ENGINE - FUEL AND CONTROL - ENGINE FUEL AND CONTROL - FUEL SYSTEM TUBES - INTRODUCTION  
OF REVISED HP SERVO EXTERNAL FUEL TUBE ASSEMBLY WITH WELDED-IN LUG AND AMENDED CLIPPING  
- CATEGORY CODE 7 - MOD.ENG-73-0116

V2500-ENG-73-0116

View looking downwards - Portside  
Fig.1

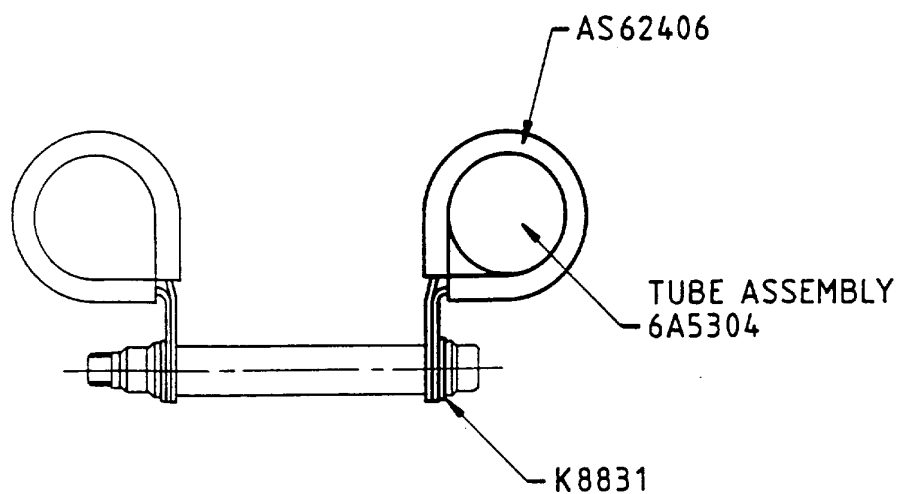
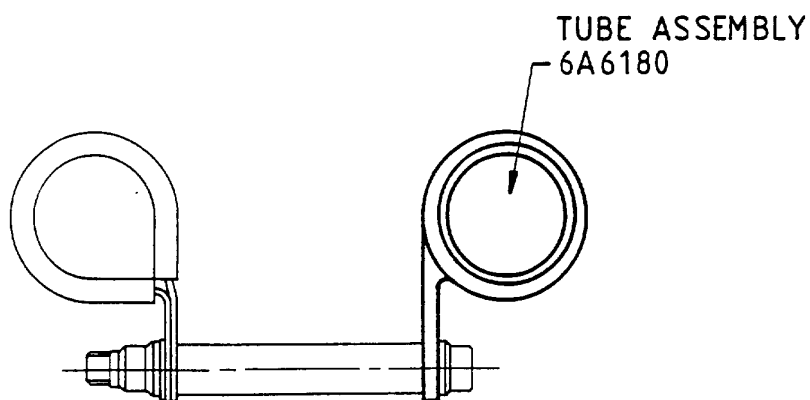
- (1) This modification introduces a different method to attach the HP-servo fuel-tube assembly to clip point CP5747 by the addition of a permanent fixed location point.

- (a) The HP-servo fuel-tube assembly is changed. A welded-in lug has been added to give a fixed position for clipping point CP5747.
- (b) Clip points CP5747 and CP6058 have changed.
- (c) The ATA Fig Item numbers for the end connectors and nuts, within the HP-servo fuel-tube assembly have changed. This change has no effect on the hardware.
